1637 N. Wilcox Ave
DOT Case No. GEN 18-47208

Subject: **TRAFFIC ANALYSIS FOR THE PROPOSED MIXED-USE DEVELOPMENT
PROJECT LOCATED AT 1637 NORTH WILCOX AVENUE**

FIGURE 2-1
PROJECT SITE PLAN
GROUND FLOOR PLAN

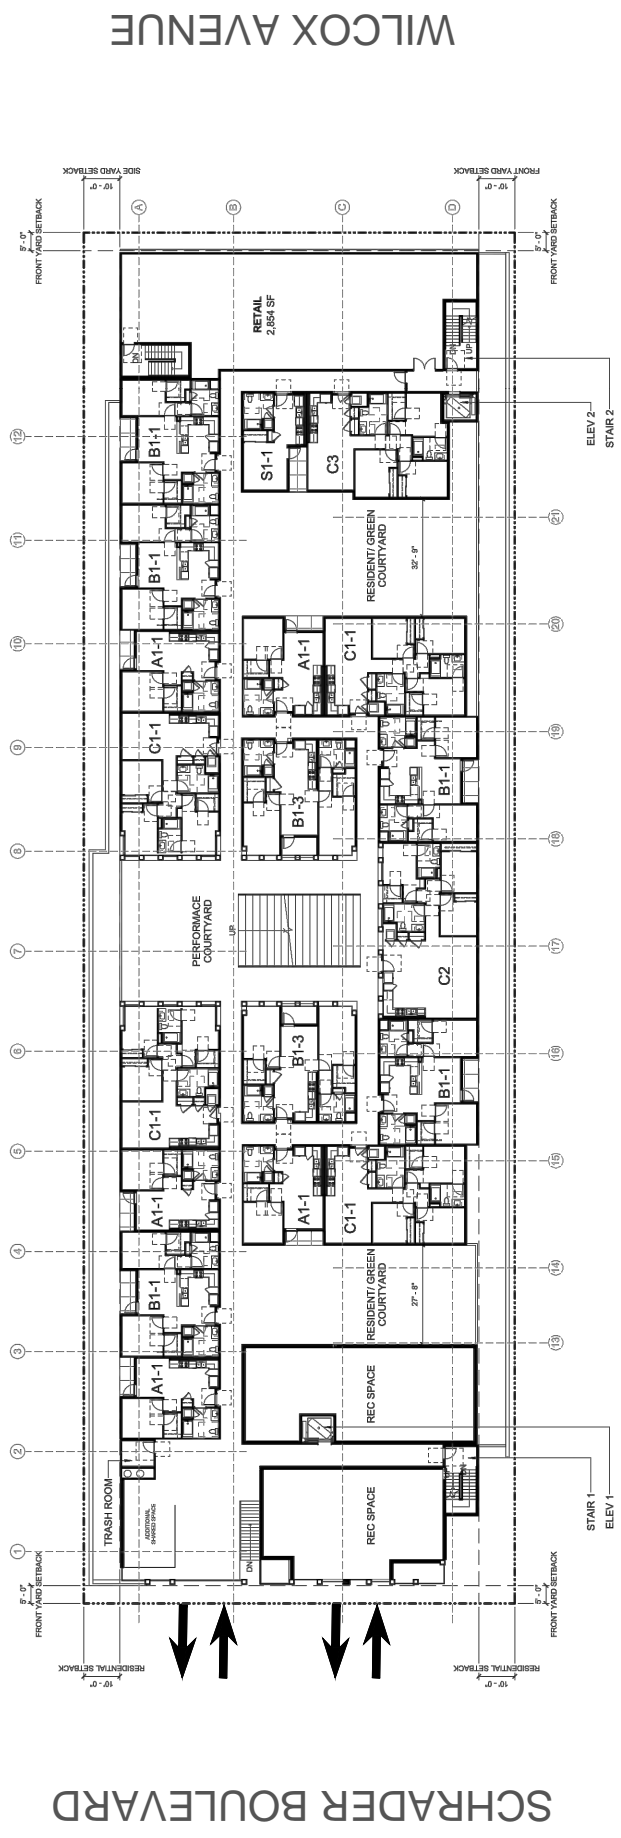
The conceptual site plan for the project, see **Attachment 3** is acceptable to DOT. However, the review of this study does not constitute approval of the dimensions for any new proposed driveways. This requires separate review and approval and should be coordinated with DOT's Citywide Planning Coordination Section (201 N. Figueroa Street, 5th Floor, Room 550, at 213-482-7024). In order to minimize and prevent last minute building design changes, the applicant should contact DOT for driveway width and internal circulation requirements prior to the commencement of building or parking layout design. All new driveways should be Case 2 driveways.
